CHANDIGARH HOUSING BOARD

This drawing supersedes drg. no. 21 job no. 162 approved by PAC (L) on 29.07.2024. The car and the shaft size of the lift has been revised to 1100mm x 1300mm (car size) and 1900mm x 2000mm (minimum) respectively with clear door opening of 900mm, as was decided in the meeting of PAC (L) held on 25.08.2025, the decision of which was circulated vide memo no. 2273893 dated 26.08.2025. The conditions shall remain the same as approved earlier.

162 JOB NO.
 25 DRG. NO.
STANDARD DESIGN OF G.H.S. IN WEST OF SECTOR - 38 CHANDIGARH. (U.T.) H.I.G. (LOWER)

SECOND FLOOR PLAN

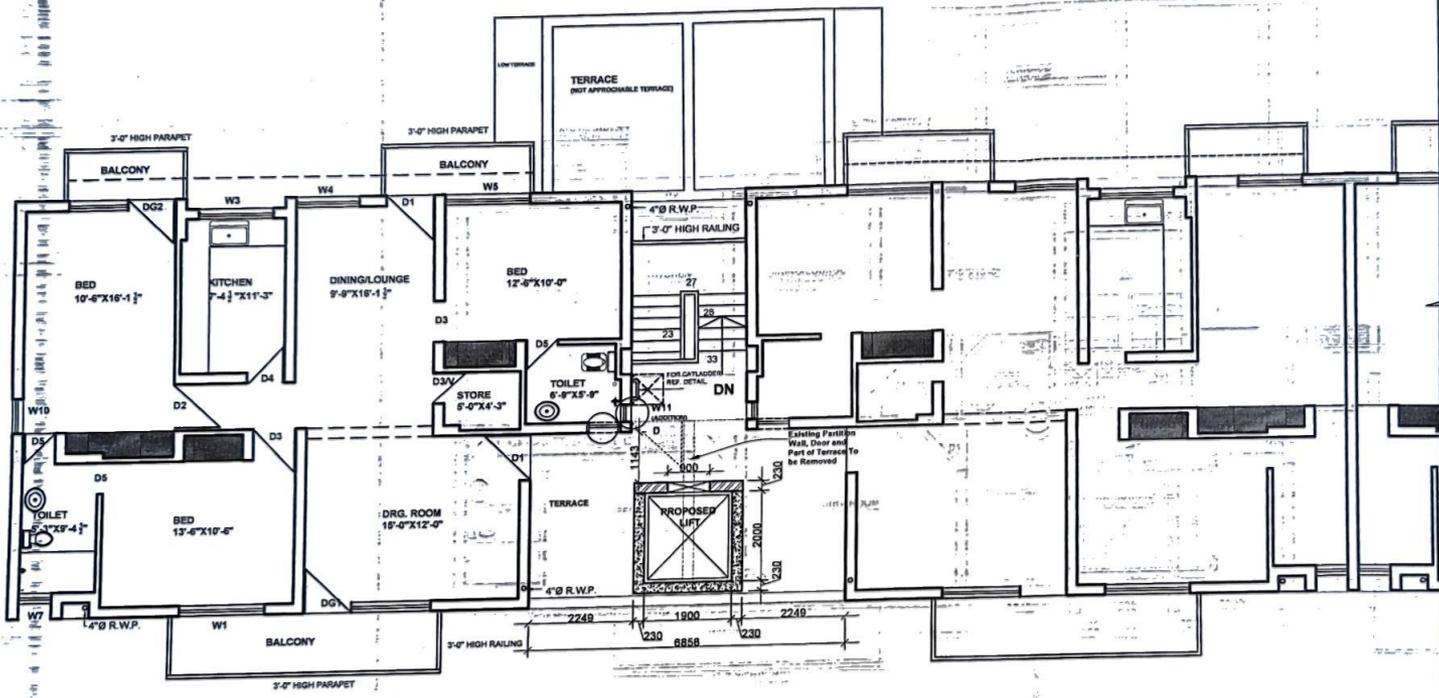
NOTE:
 This drawing supersedes drg. no. 23 job no. 162 approved by PAC (L) on 29.07.2024. The car and the shaft size of the lift has been revised to 1100mm x 1300mm (car size) and 1900mm x 2000mm (minimum) respectively with clear door opening of 900mm, as was decided in the meeting PAC (L) held on 25.08.2025, the decision of which was circulated vide memo no. 2273893 dated 26.08.2025. The conditions shall remain the same as approved earlier.

TERRACE FLOOR PLAN

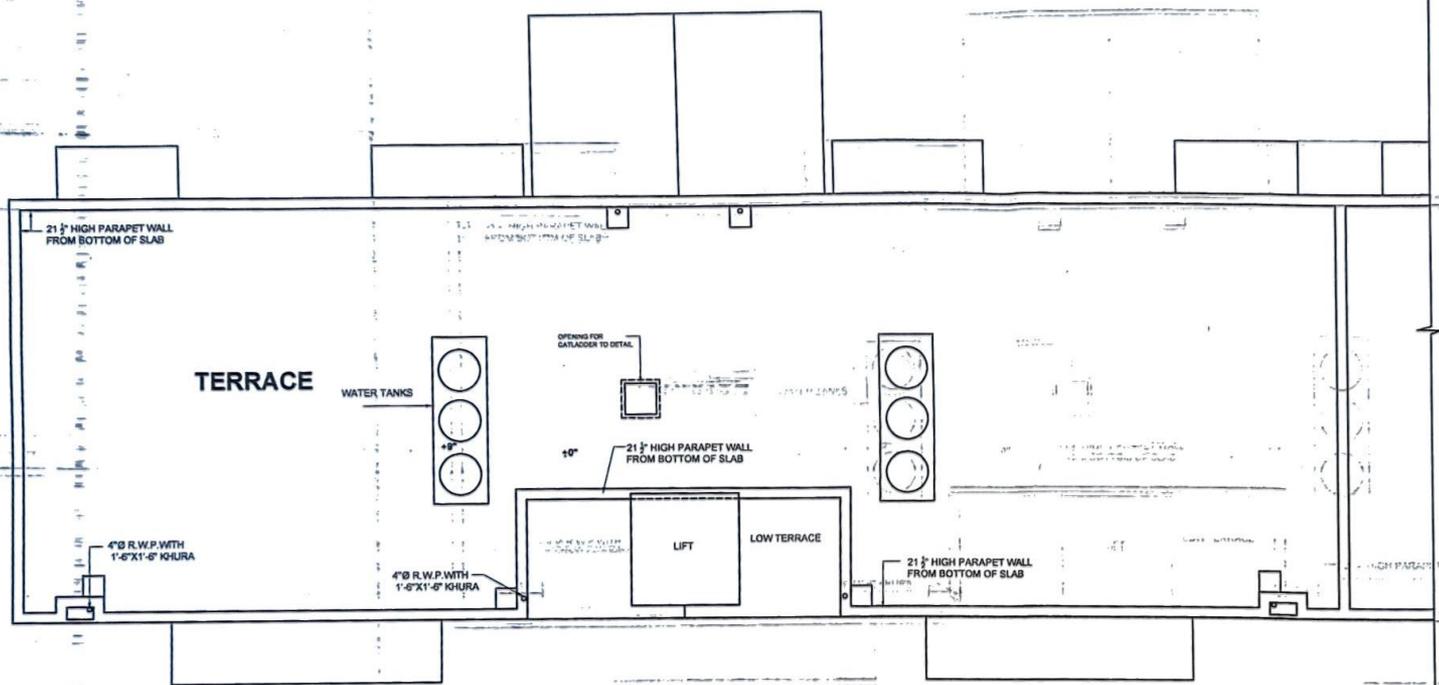
This drawing supersedes drg. no. 24 job no. 162 approved by PAC (L) on 29.07.2024. The car and the shaft size of the lift has been revised to 1100mm x 1300mm (car size) and 1900mm x 2000mm (minimum) respectively with clear door opening of 900mm, as was decided in the meeting PAC (L) held on 25.08.2025, the decision of which was circulated vide memo no. 2273893 dated 26.08.2025. The conditions shall remain the same as approved earlier.
